# Tacoma Mall Neighborhood Subarea Plan

## ATTACHMENT 1: Issues Summary and Staff Recommendations IPS Council Committee - February 28, 2018

**Recommended RGC and Zoning Boundary Change:**

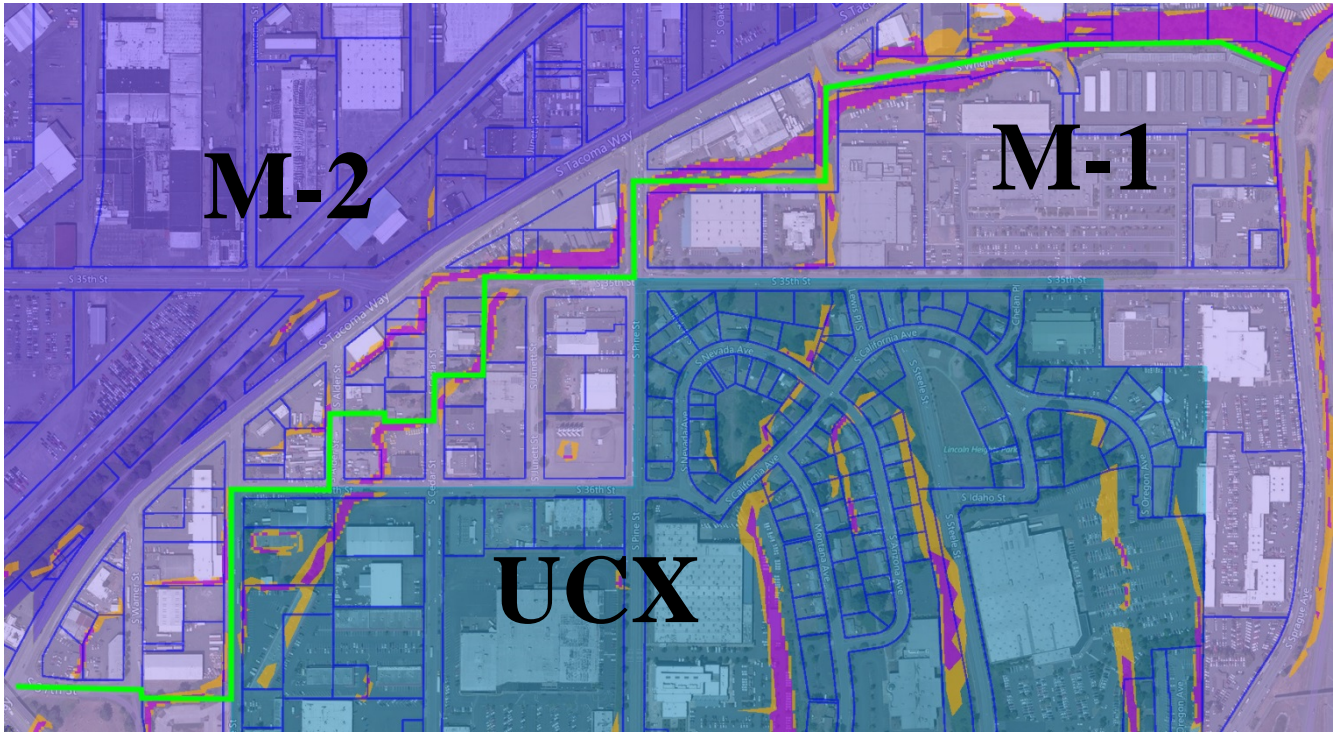
The green line indicates a revised RGC and zoning district boundary that generally follows the top of the slope, adjusted to accommodate existing parcel lines. Within this revised RGC boundary, mixed-use zoning districts would apply as proposed by the Planning Commission.

The area immediately outside of the revised RGC boundary would remain in the M-1 Light Industrial District, thus expanding the distance and grade separation between heavy industrial and residential or mixed-use development.

## Madison District Zoning/Green Streets Alternative:

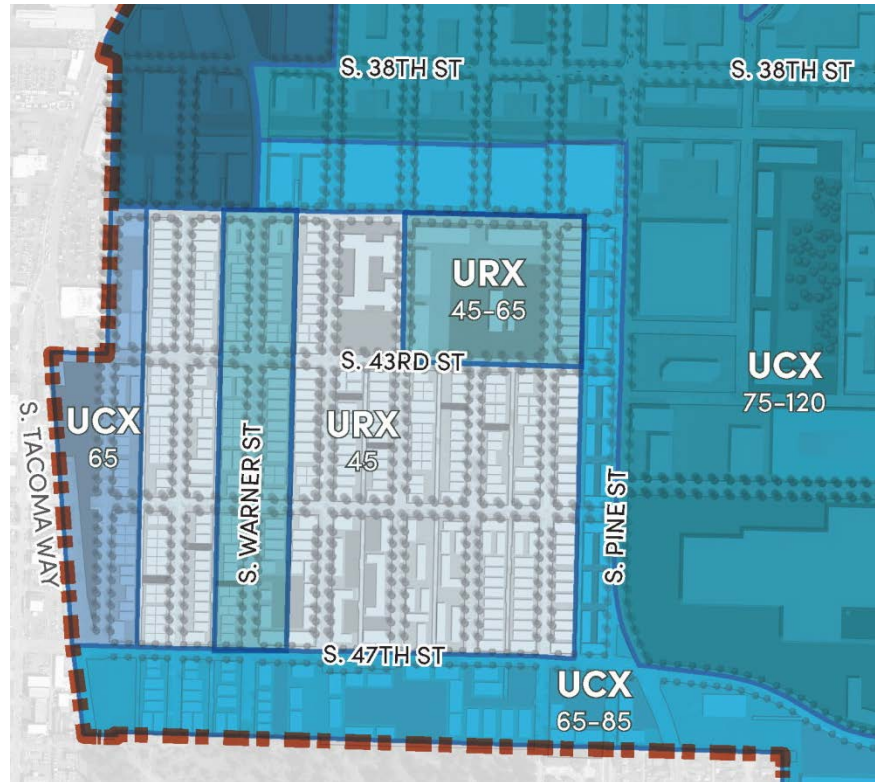
This map depicts an alternative considered but not selected by the Planning Commission.

The alternative would allow 65 feet along Warner Street and around the Madison School site.

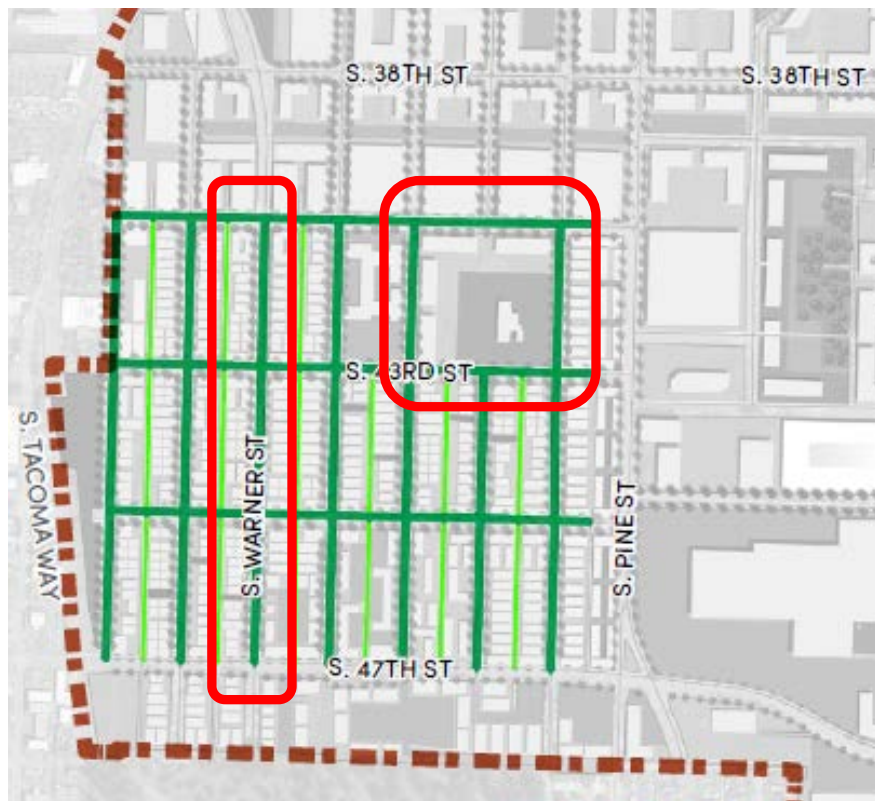
If the zoning alternative above were selected, the stormwater strategy would be revised as well.

The areas where height is increased would be removed from the Green Stormwater Strategy and no longer be designed as pervious pavement streets, due to the additional anticipated density (see red outlines).
